UNITED STATES PATENT AND TRADEMARK OFFICE

APPLICATION NO.	FILING DATE	FIRST NAMED INVENTOR	ATTORNEY DOCKET NO.	CONFIRMATION NO.
10/684,684	10/15/2003	Kohci Yamanaka	Q76899	3402
23373 7590 08/02/2007 SUGHRUE MION, PLLC 2100 PENNSYLVANIA AVENUE, N.W. SUITE 800 WASHINGTON, DC 20037			EXAMINER GARCIA, ERNESTO	
			ART UNIT 3679	PAPER NUMBER
			MAIL DATE 08/02/2007	DELIVERY MODE PAPER

Office Action Summary

DETAILED ACTION

FIG. 6

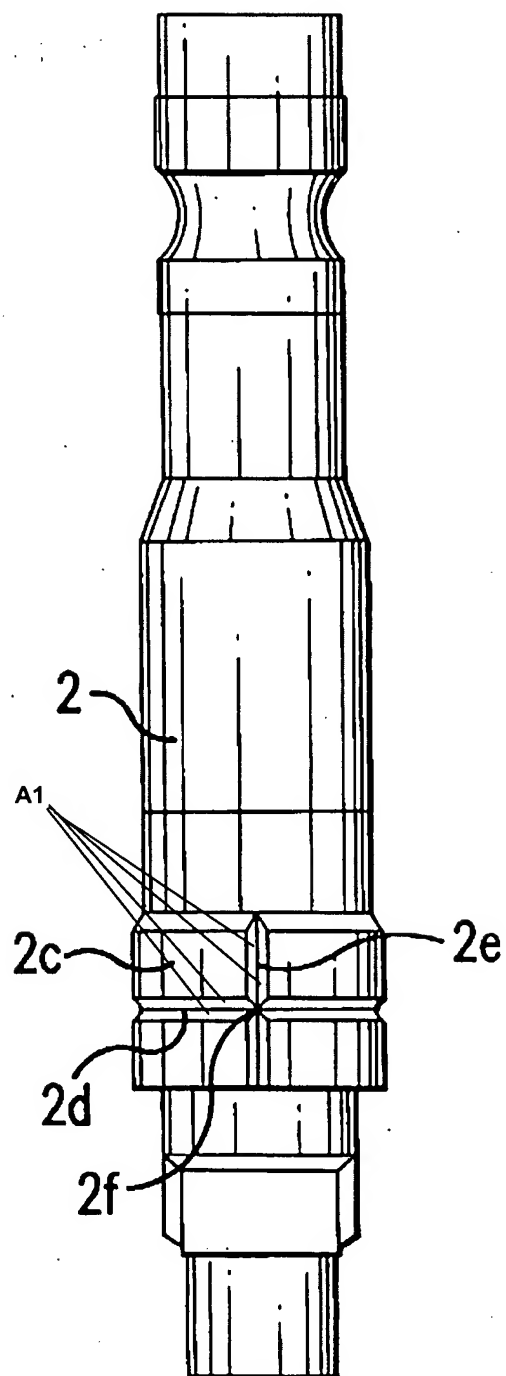
Attachment: one marked-up page of Yamanaka et al., 2003/0136604
